City of Pawtucket, RI

***** **Addendum #1** *****

RFP # 16-047

Veteran's Park Fence Replacement

Drawing Title: Construction Detail (Base Bid)
Project: Veteran's Park Fence Replacement

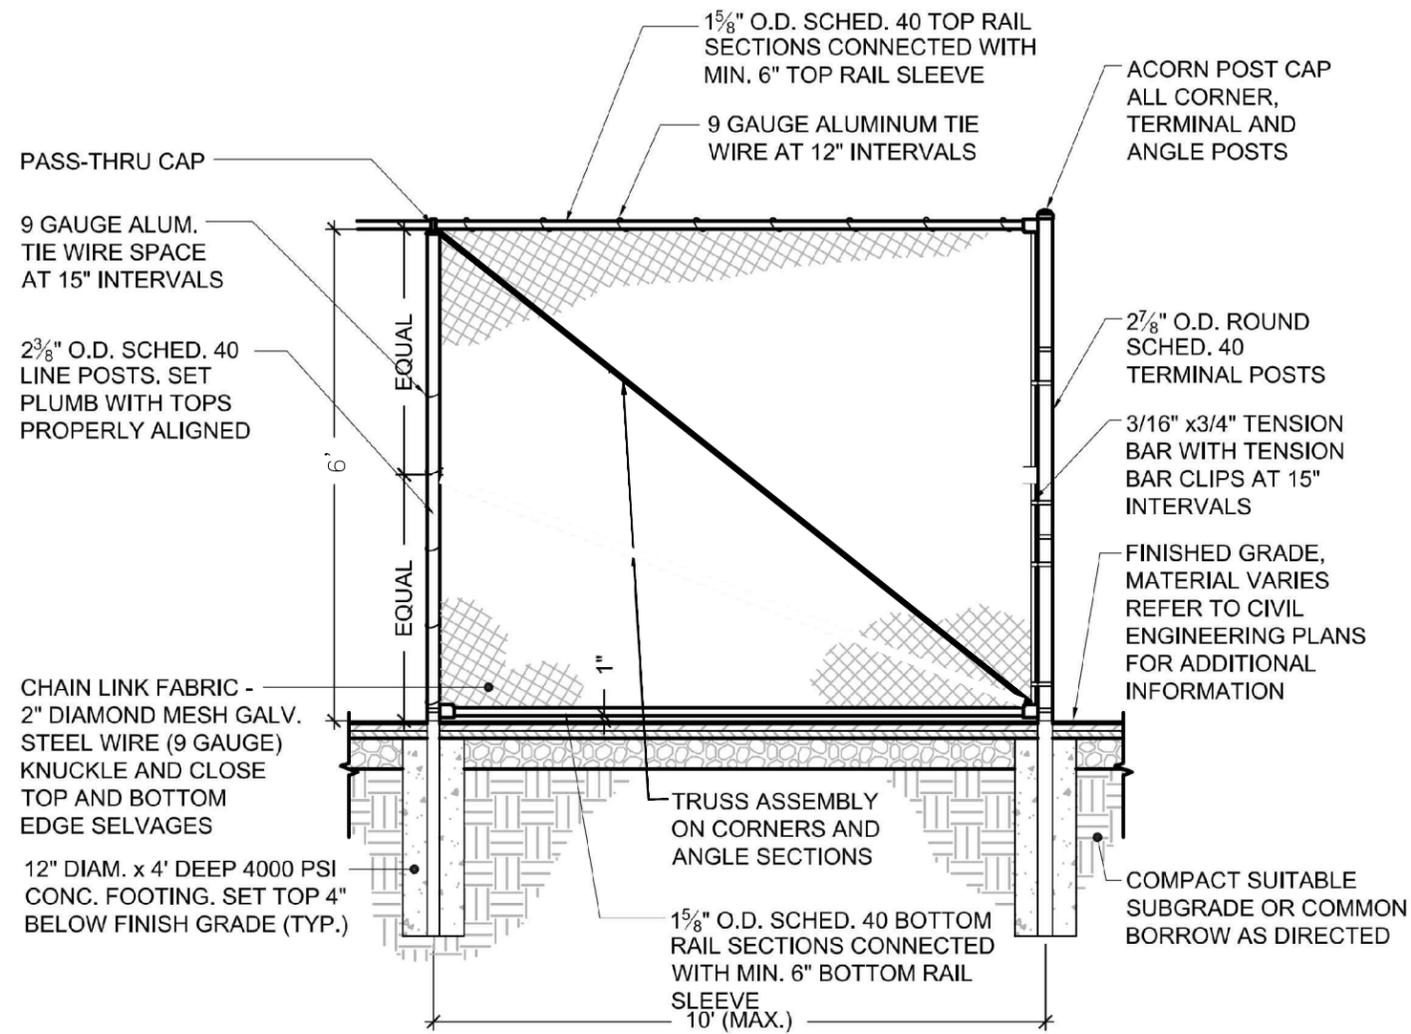
ITEM 2-4: Construction Details Issued for Bid (Appendix E of RFP)

DELETE: Construction Detail Issued for Bid

INSERT: Attached, modified Construction Details, including:

- Construction Detail (Base Bid)
- Construction Detail (Bid Alt. #2)

Drawing Title: Construction Detail (Bid Alt. #2)
Project: Veteran's Park Fence Replacement

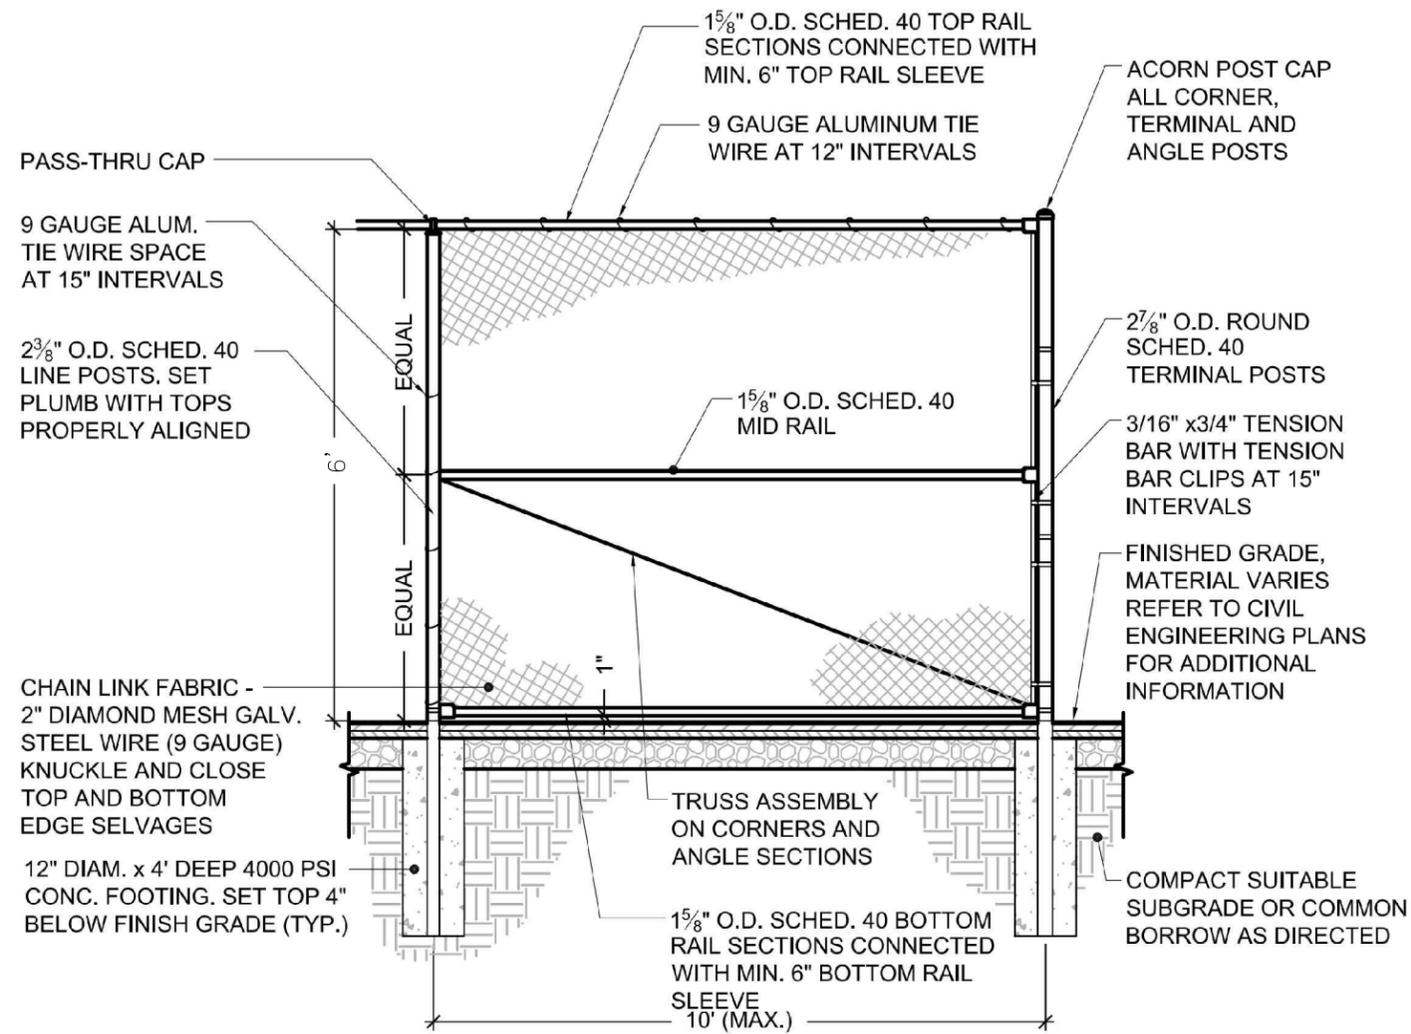
INSERT: **4.3.3 Bid Alternate #2 Scope of Work**

The Project scope of work per Bid Alternate #2 shall be in all respects the same as the scope of work per the Base Bid, with the following exception(s):

- Furnish and install chain link fence per the modified construction detail provided in Appendix E. The modified detail includes a middle rail.
